RESPONSES TO INVESTIGATION REPORTS SUBMITTED BY LINE ORGANIZATIONS AND
NOT YET REVIEWED FOR ACCEPTABILITY

SUBJECT: WATTS BAR NUCLEAR PLANT - NUCLEAR SAFETY REVIEW STAFF INVESTIGATION REPORT IN-85-442-X13 - SEISMIC TRENCHES - RELATED EMPLOYEE CONCERNS IN-85-066-001, IN-85-472-007, IN-85-496-001, AND WI-85-040-004

SUBJECT: NUCLEAR SAFETY REVIEW STAFF INVESTIGATION REPORT IN-85-442-X13 - SEISMIC TRENCHES

EMPLOYEE CONCERN IN-85-442-X13

WATTS BAR NUCLEAR PLANT UNDERGROUND BARRIER FIGURE 1		
TENNESSEE VALLEY AUTHORITY DIVISION OF DAMS AND RESERVOIRS		
DESIGNED BY	PROJECT NO.	DATE
DRAWN BY	NO. OF SHEETS	NO. OF SHEETS
CHECKED BY	APPROVED BY	DATE
MEMPHIS, TENNESSEE

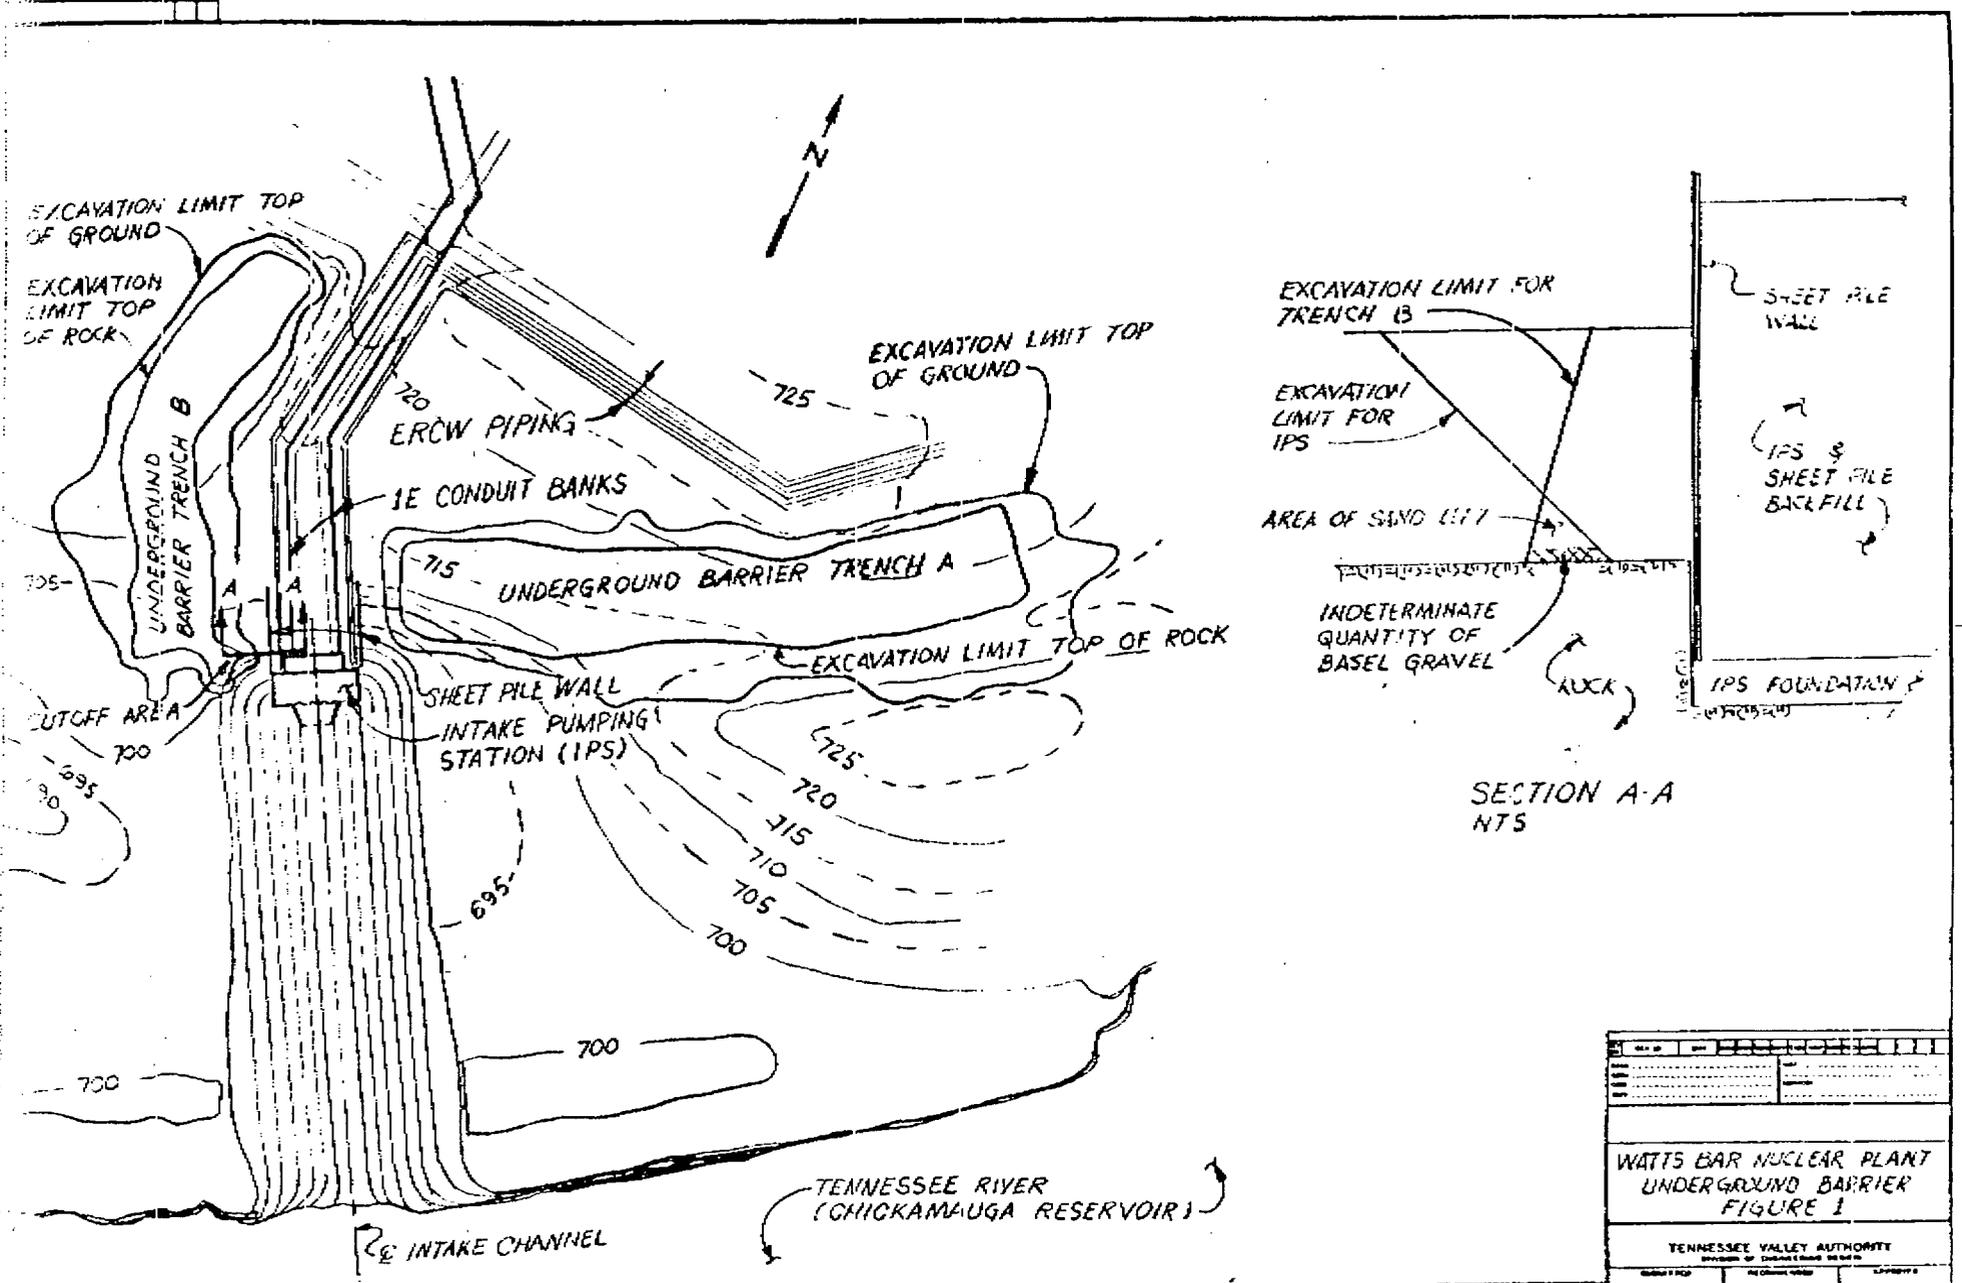
The design drawing provision to "assure adequate cutoff of potentially liquefiable sands" was not adequately prescribed or implemented. The "gap" includes an undetermined quantity of questionable "sands" which were not removed in an unsuccessful attempt to tie-in the Trench B and IPS backfills.

The drawing (10N213-1 and -2) issued for construction required an adequate cutoff. Based on a visual field inspection performed when the barrier trench was being excavated and other site conditions, the cutoff is adequate. The visual field inspection was done by the OE engineer responsible for the design of the underground barrier.

It is correct that for the Trench B underground barrier, some fine sands were intentionally left between the barrier trench excavation and the former IPS excavation. In lieu of making a total cutoff and possibly undermining the Category I sheet pile wall behind the IPS, the barrier trench excavation (cutoff) was extended to the extent evaluated to be adequate. This adequacy was based on (a) the geometrical relationship of the Trench B excavation and backfill with the IPS and intake channel excavation and backfill, and (b) on the fact that any loss of material from behind the underground barrier due to liquefaction must be preceded by movement of a massive amount of material on the flood plain into the river.

The geometrical relationship of the excavation and backfill limits of Trench B, the IPS, and the intake channel are such that only a small zone of sand was left in place. The excavation limits for these three features overlap except near the top of rock where the sand zone exists. Figure 1 shows the relationship of Trench B, IPS, and the Intake Channel. Section A-A on figure 1 shows the overlap of the excavation limits of Trench B and IPS. Also

Section A-A shows the small zone of in situ material left in place. The zone is estimated (based on construction photographs and visual observation of the trench excavation) to be approximately 3- to 4-feet high and 5- to 6-feet wide at the base or top of rock. This zone is probably from 100 to 125 feet in length in the area of concern. This zone also contains an indeterminate amount of nonliquefiable basal gravel. The basal gravel is the material layer just above rock at the plant and varies in thickness from 1 \pm foot to 8 \pm feet. This material was not removed during the over excavation of the intake channel. In fact, the basal gravel provides the foundation for the earthfill that was placed to construct the intake channel slopes.

The other site condition, that affected the engineer's evaluation that the cutoff was adequate, is that a massive volume of material would have to be moved off the flood plain and into the river to create a void where the potentially liquefiable sands behind the barrier could move.
